TECHNICAL EVALUATION REPORT ON THE
ADEQUACY OF STATION ELECTRIC
DISTRIBUTION SYSTEM VOLTAGES FOR THE
SURRY POWER STATION, UNITS 1 AND 2

(Docket Nos. 50-280, 50-281)

September 1, 1982

Lawrence
Livermore
Laboratory

FIGURE 1 - SURRY UNITS 1 AND 2 - ELECTRICAL ONE-LINE DIAGRAM

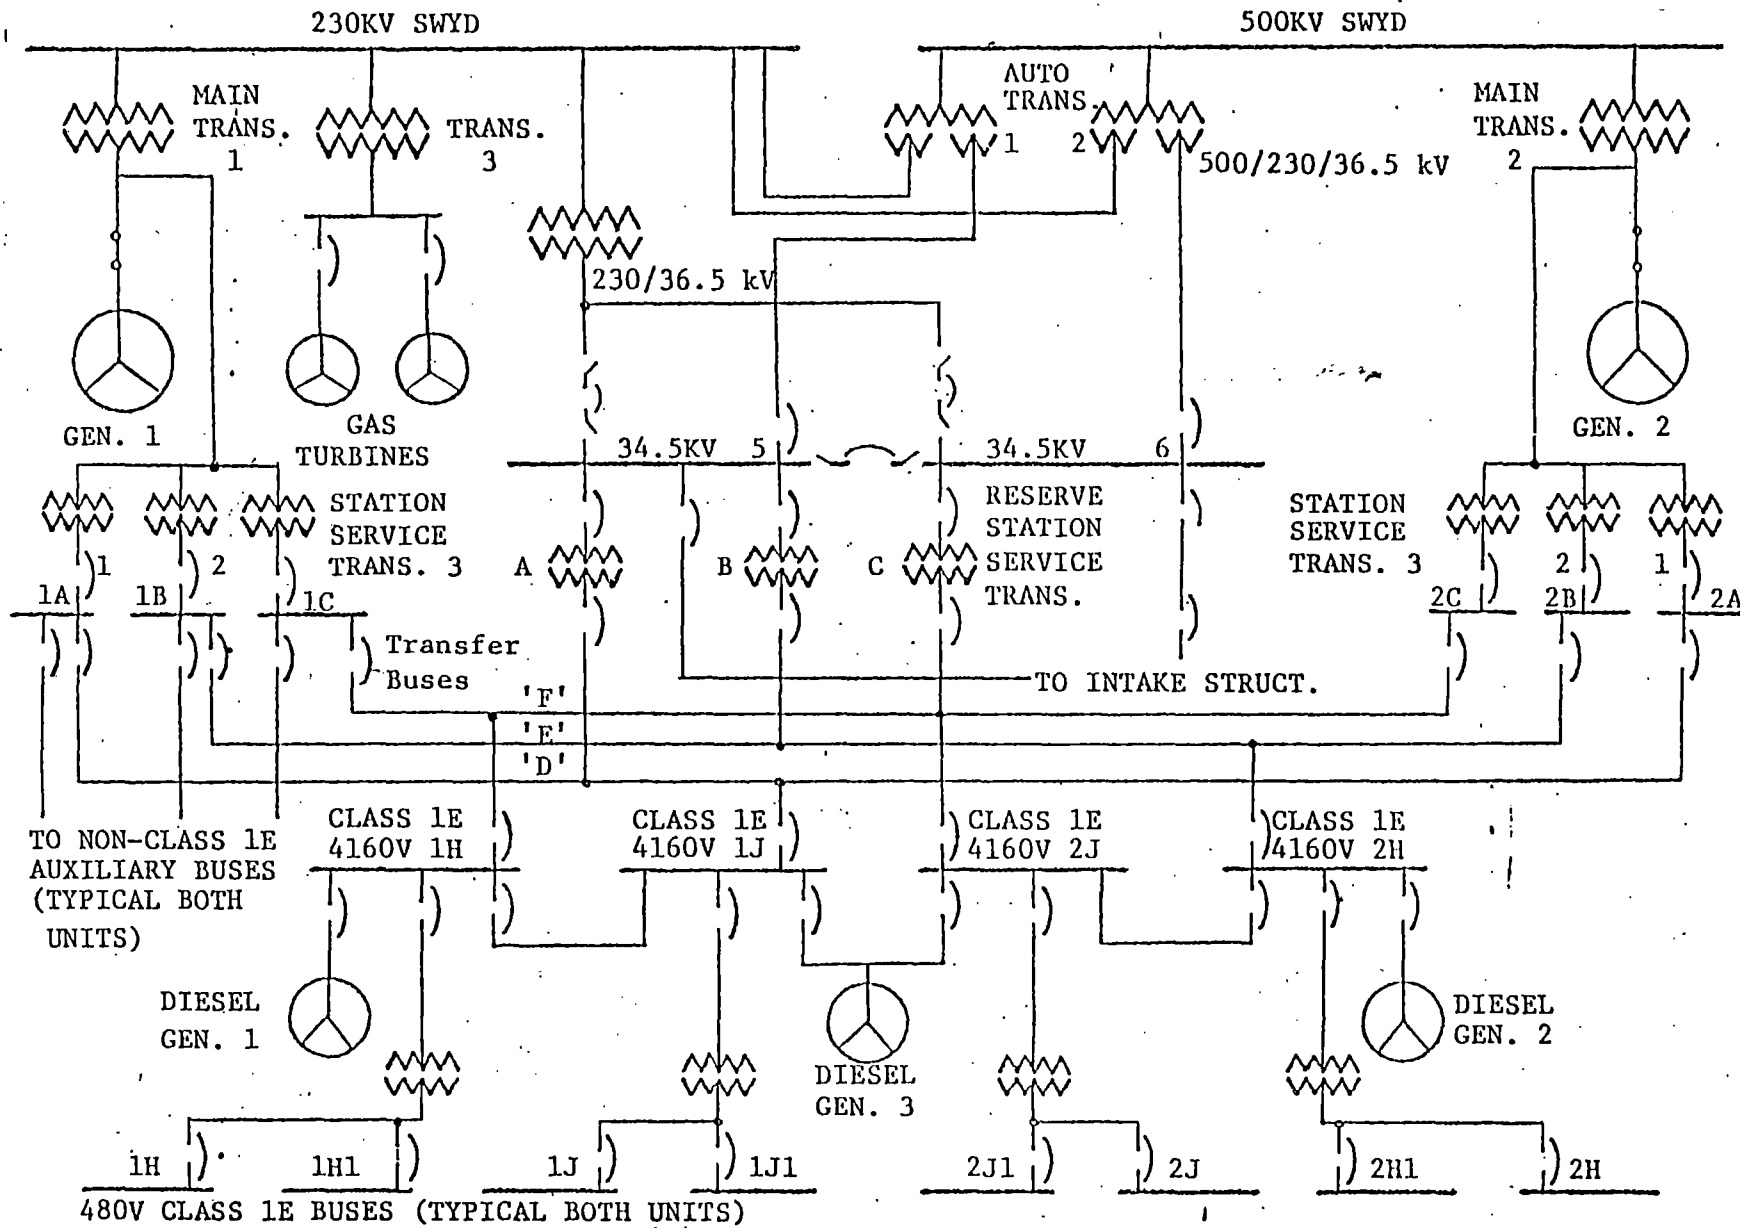
An electrical one-line diagram for Surry Power Station, Units 1 and 2 is shown in Figure 1. Each unit's generator is connected to the transmission system through it's own main transformer. The output of the the generator is stepped up from 22 kV to 230 kV and 22 kV to 500 kV for Units 1 and 2, respectively. The 230 kV system and the 500 kV system is tied together by two 500/230/36.5 kV autotransformers (preferred offsite source). The autotransformers supply two 34.5 kV buses from which the three 34.4/4.16 kV reserve station service transformers (RSST's), two 34.4/4.16 kV intake structure transformers and four 34.5 kV reactor banks are fed. The RSST's A, B, and C supply the 4 kV transfer buses D, E, and F respectively. Transfer bus D supplies Class 1E bus 1J and station service buses 1A and 2A. Transfer bus E supplies

Class 1E bus 2H and station service buses 1B and 2B. Transfer bus F supplies Class 1E buses 1H and 2J and station service buses 1C and 2C. The Class 1E buses (two 4160-volt and four 480-volt Class 1E buses at each unit) are fed from the RSST's at all times. The RSST's have a load tap changer (LTC) on their secondary winding which is set to maintain a 4300-volt output and which will provide a $\pm 10\%$ voltage adjustment over the full range of operation. The adjustment capability is provided by 32 taps each of 0.625% voltage adjustment.
